DA-83/2023 Edmondson Park Precinct 3, RESPONSE TO REQUEST FOR INFORMATION

PROJECT
LANDCOM
EDMONDSON PARK PRECINCT 3
LOT 5 DP1272931
CAMPBELLTOWN ROAD

DRAWING TITLE
SIGHT DISTANCE LAYOUT PLAN
SHEET 1

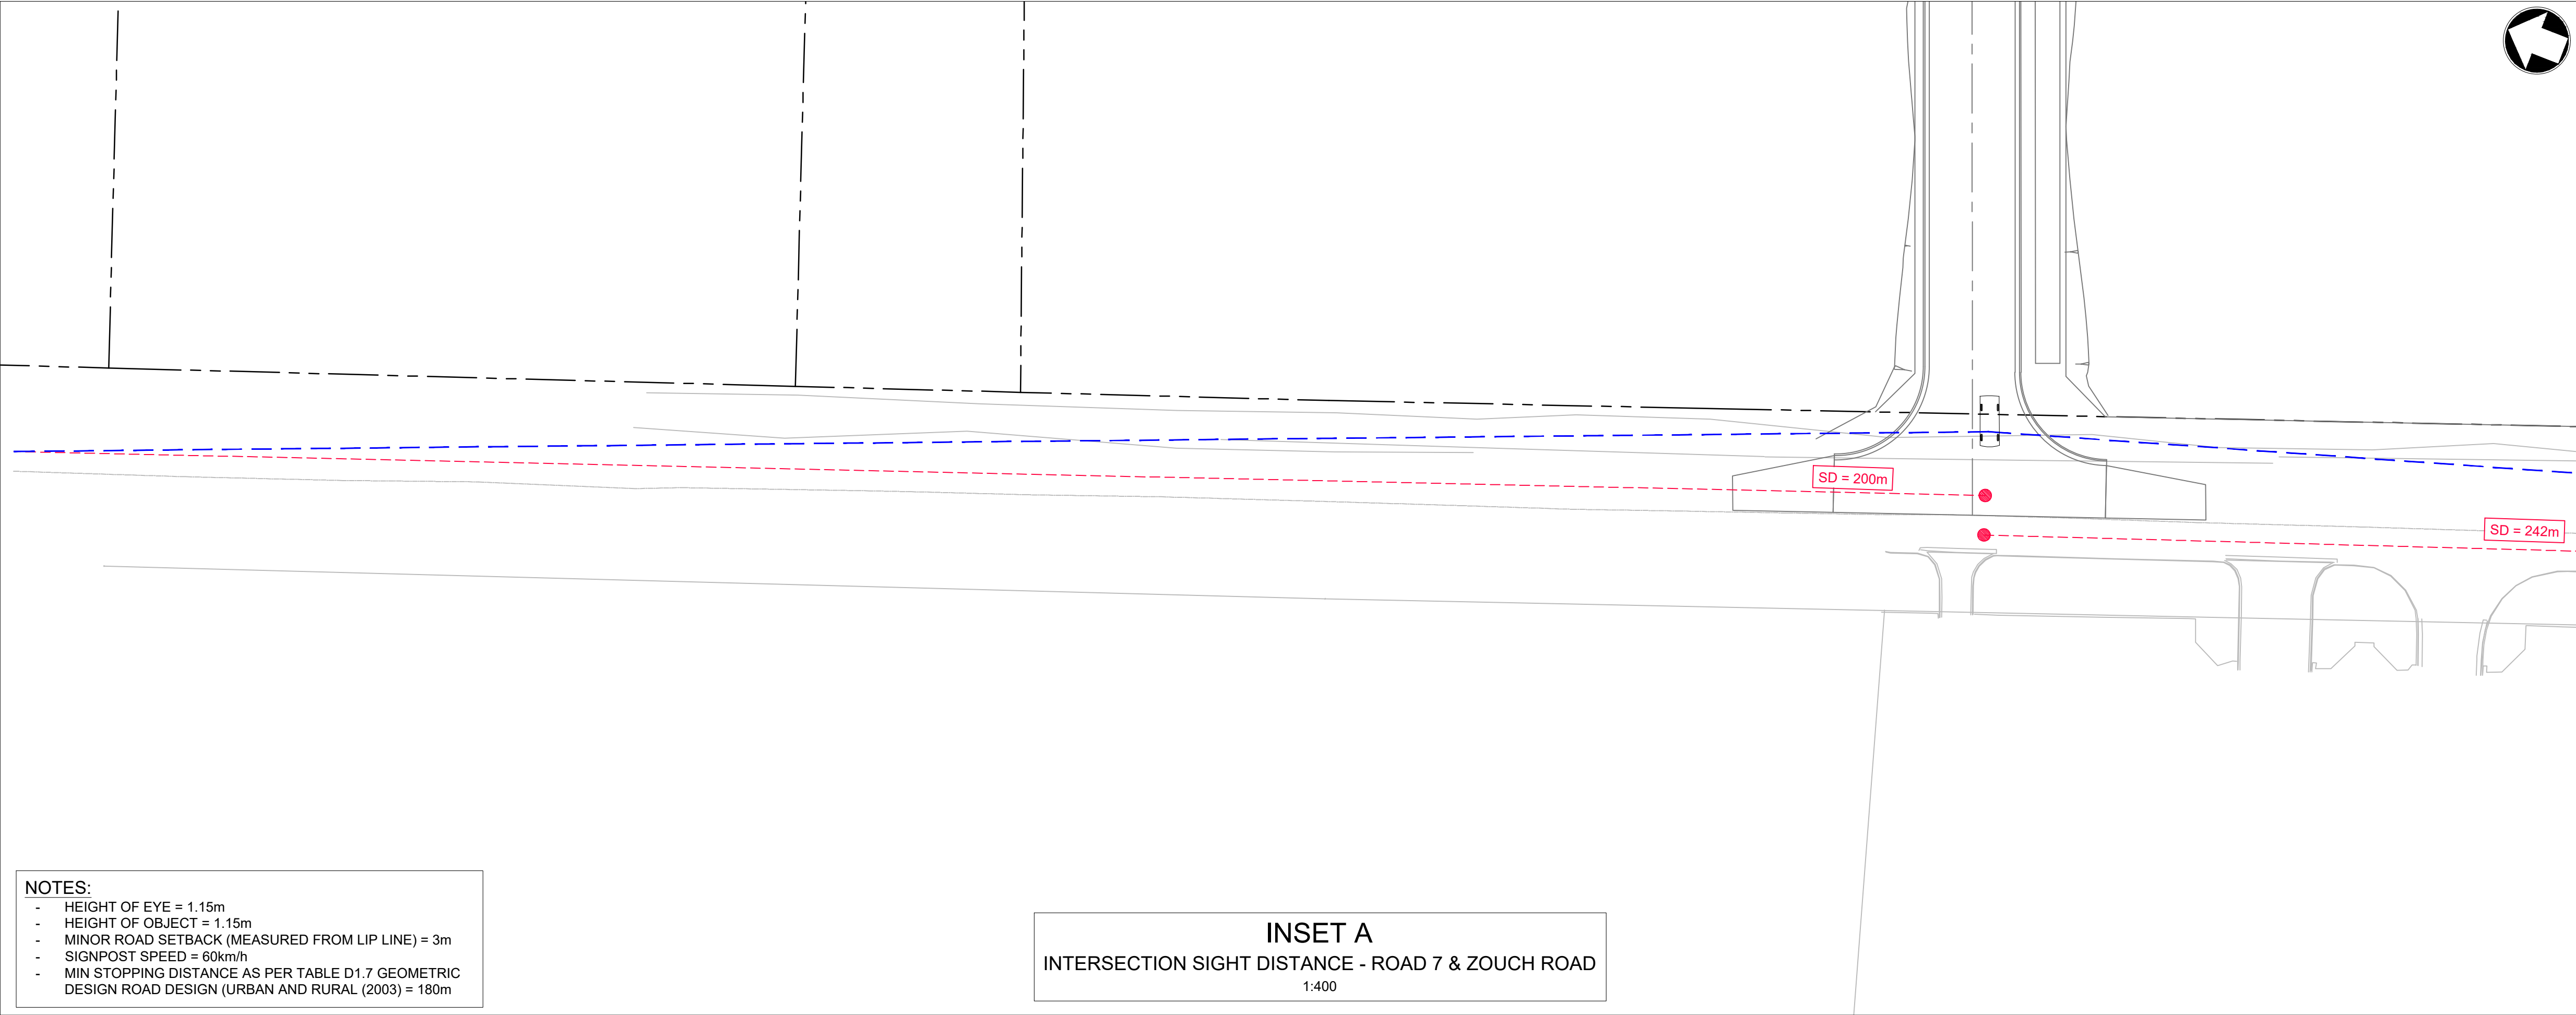
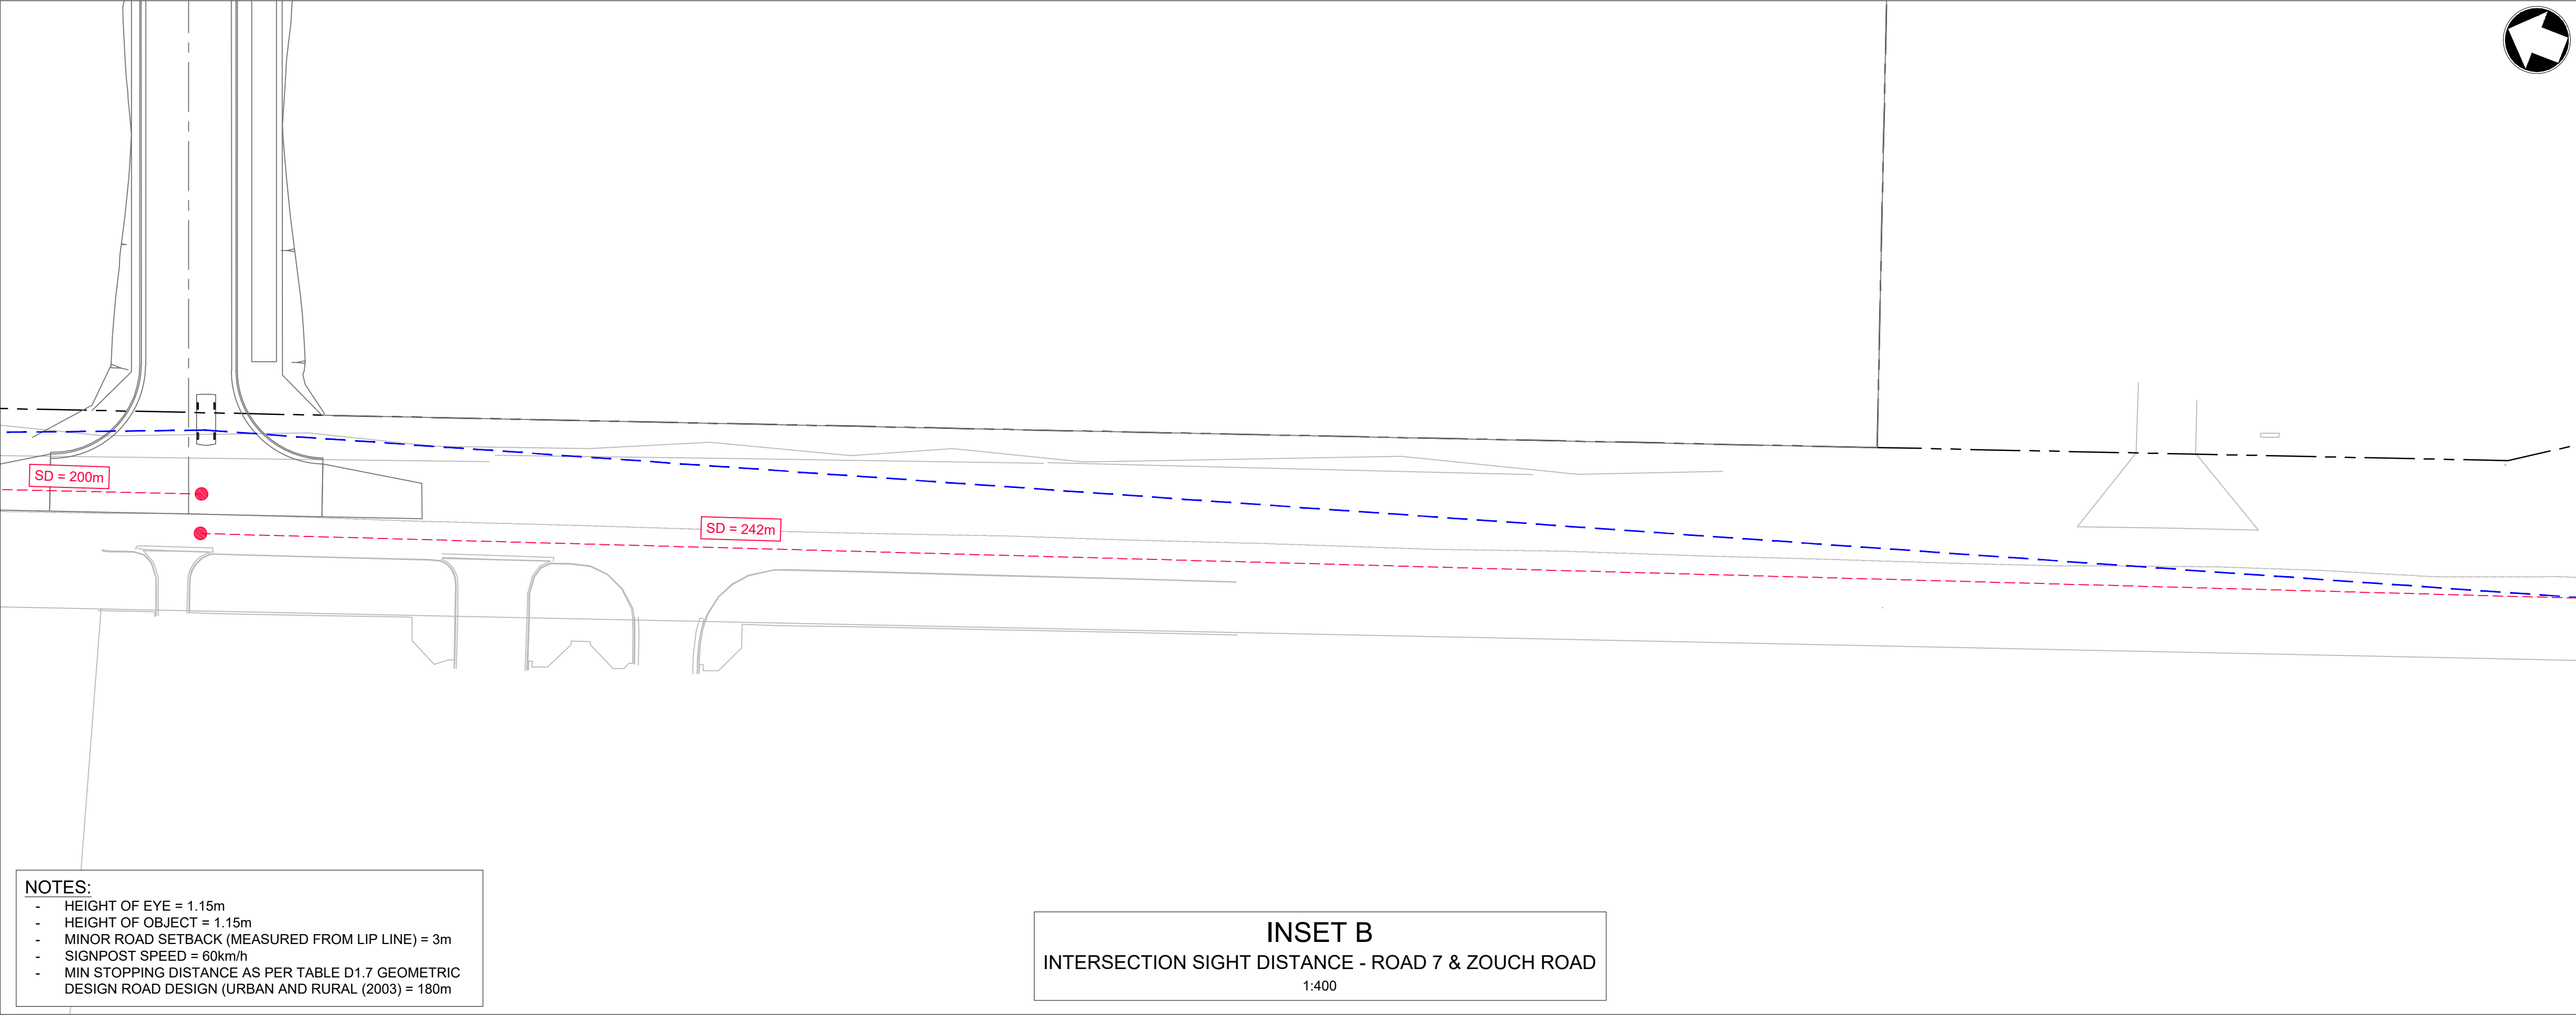
Traffic matters raised by Council on 2 February 2024	Proponent responses
<i>Zouch Road</i>	
<p>19. Council considers the intersection of Zouch Road and Road 7 intersection may require a roundabout given the expected traffic that is likely to use it. If the applicant contests this, they need to submit documentation including road safety audit to justify that.</p>	<ul style="list-style-type: none"> – Zouch Road is considered as a minor (secondary) access to Precinct 3 as Zouch Road meets Campbelltown Road as a priority intersection, whereas Macdonald Road is the primary access to Precinct 3 where it meets Campbelltown Road as a set of traffic signals and its proximity to the town centre. – The traffic distribution pattern adopted in the Ason TIA, suggested only 2% of traffic is heading to / from the west and the majority of this traffic will still be using the Macdonald Road access to access Precinct 3. Hence the traffic increase at the intersection of Zouch Road and Road 7 is expected to be negligible (less than 10 veh/hr) and this intersection will continue to operate at LoS A or B during the peak hours as a priority intersection. No upgrade is required to cater for the expected traffic increase at this location. – Sight distance and safety review undertaken by IDC (as shown in Appendix A) confirms that sight distance complies with <i>Austroads Guide to Road Design Part 4A and AS2890.1: 2004</i> at the intersection of Zouch Road and Road 7 for both approaching traffic and traffic waiting to enter Zouch Road. – A road safety audit is typically not required at the DA stage and will be undertaken during the refinements of the road design in later design stages including detailed design stage. – Hence, there is no justification for the requirements to upgrade the intersection of Zouch Road and Road 7 to a roundabout from a traffic capacity and safety perspective.

INSET A
INTERSECTION SIGHT DISTANCE - ROAD 7 & ZOUC ROAD
1:400

INSET B
INTERSECTION SIGHT DISTANCE - ROAD 7 & ZOUC ROAD
1:400
